EIS prepared for 179 Meadowlily Road by MTE dated April 30, 2021

Reviewed by: S. Hall, S. Levin, R. Trudeau, I. Whiteside for EEPAC's Nov 2021 meeting

Figure 9: Conceptual Grading Plan

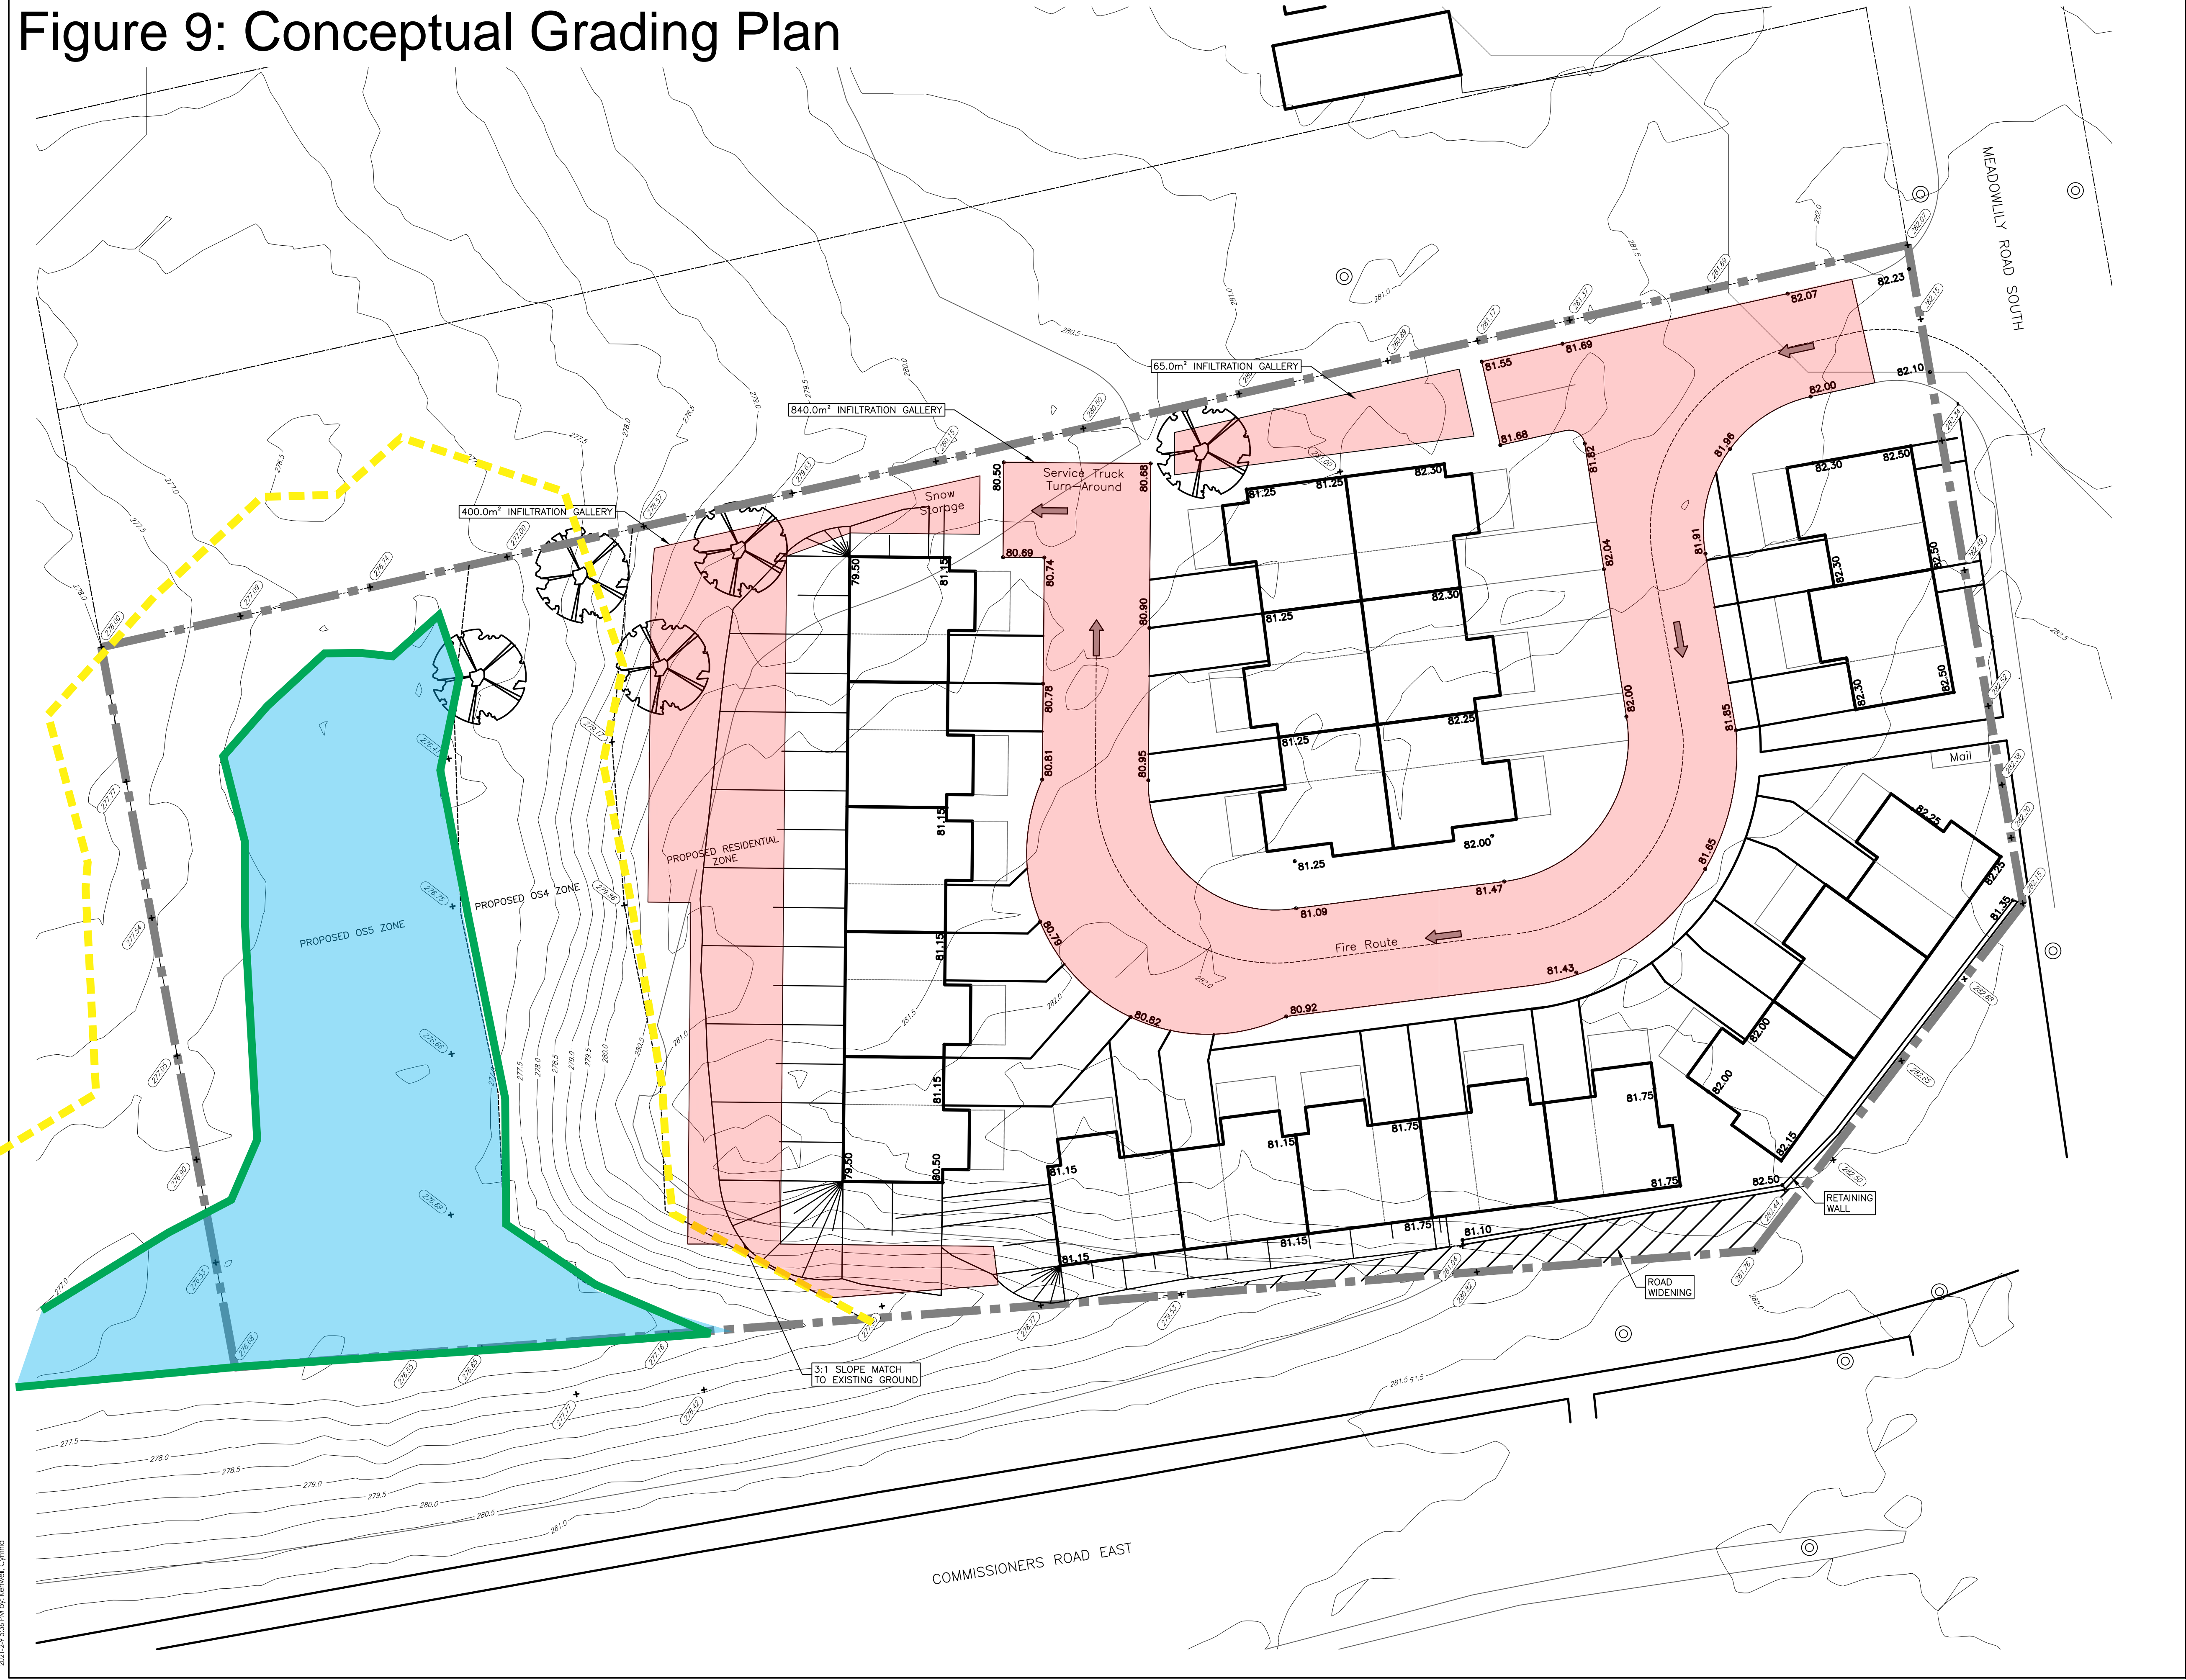
EEPAC is concerned that the buffer proposed from the ESA and the wetland inclusion is insufficient given the proposed grading to put in a retaining wall on the site. Although the buffer from the flow path of the watercourse appears to be sufficient protection, EEPAC

questions whether the proposed wetland buffer is sufficient as it is clear from the bottom of p. 18 that construction will encroach at least as close as 5 m to the feature.

It is not clear to EEPAC how the hydrological function will be protected, particularly as grading is proposed to a 3:1 slope. It is also not clear based on Stantec 2021 if or where an infiltration gallery will be.

This is a standard recommendation - there is no detail. As pointed out by Stantec, this is not a standard project. Grading and construction of the retaining wall are proposed to be within the 10 m buffer of the wetland inclusion, which EEPAC does not support.

RECOMMENDATION #6: A 10 m buffer be established and no construction take place within the 10 m buffer.

Map 8

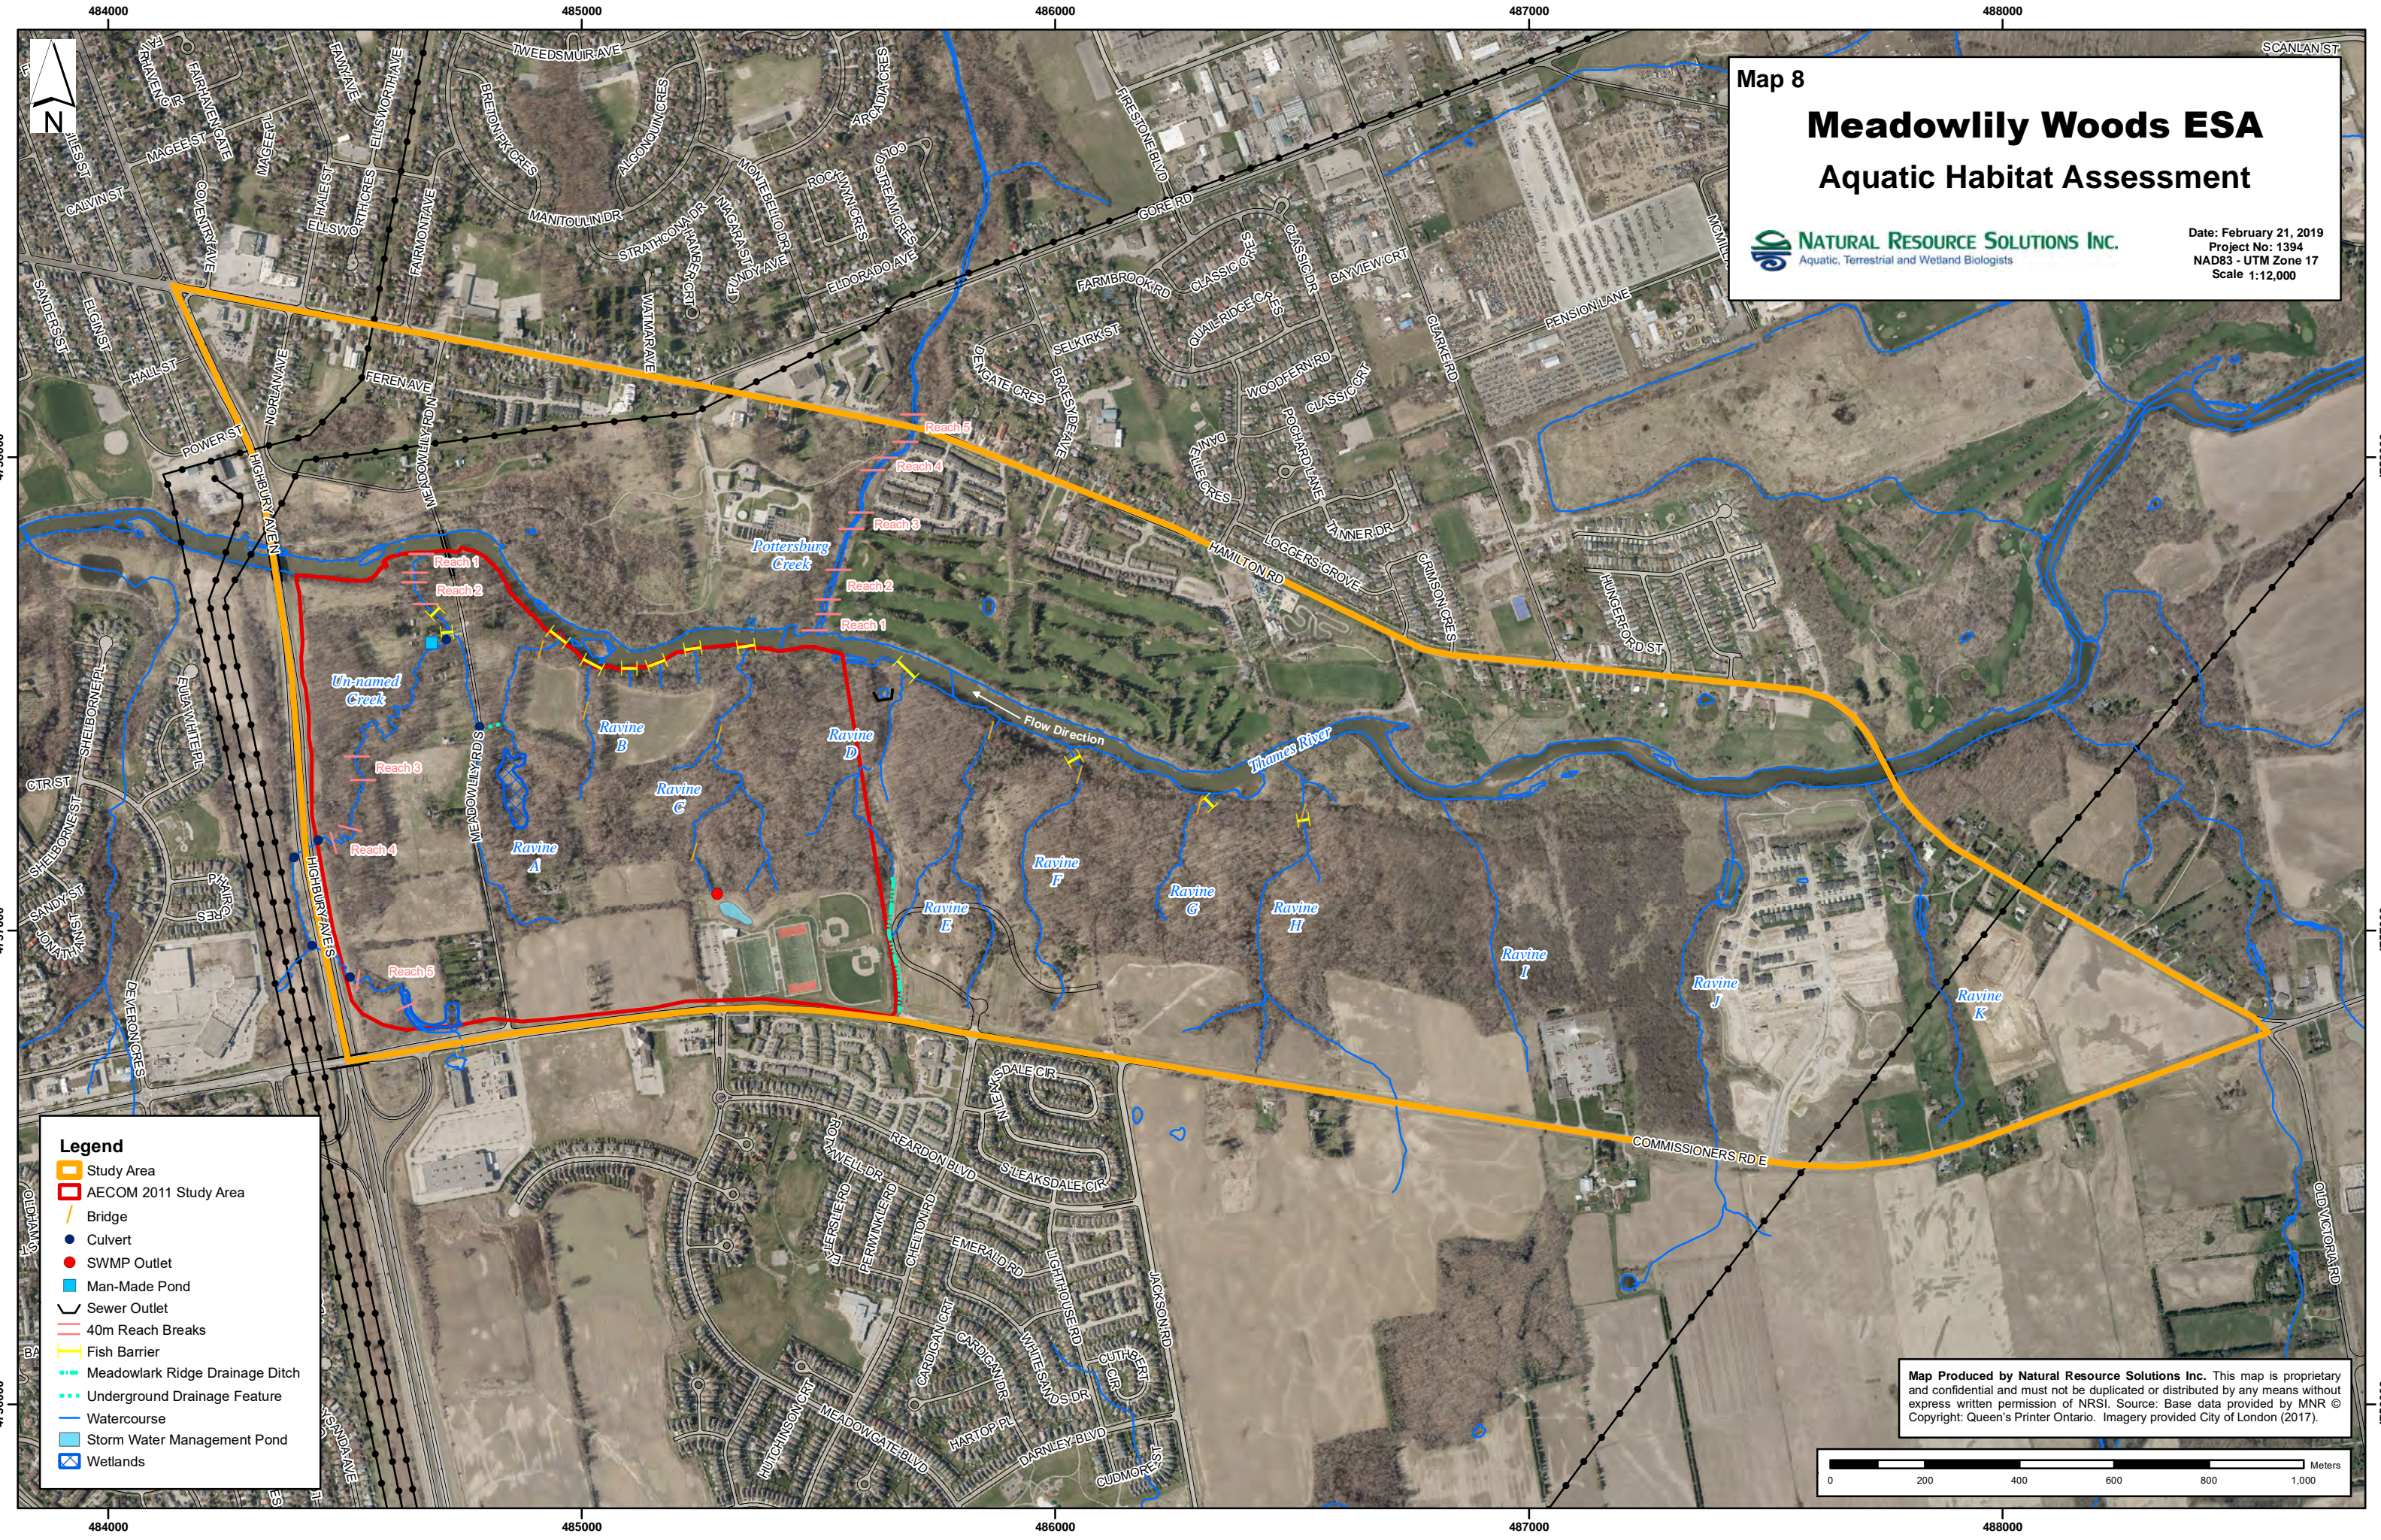
Attached are extracts from Phase 1 of the Conservation Master Plan for Meadowlily Woods ESA by Natural Resources Solutions Inc dated 2019. The watercourse is referenced from AECOM's earlier site work for the City. It is labeled 'Un-named Creek' and appears on the attached Map 8 from the Phase 1 document.

RECOMMENDATION #5: City staff review AECOM's study of this tributary of the Thames as data about it is not reported in the current EIS.
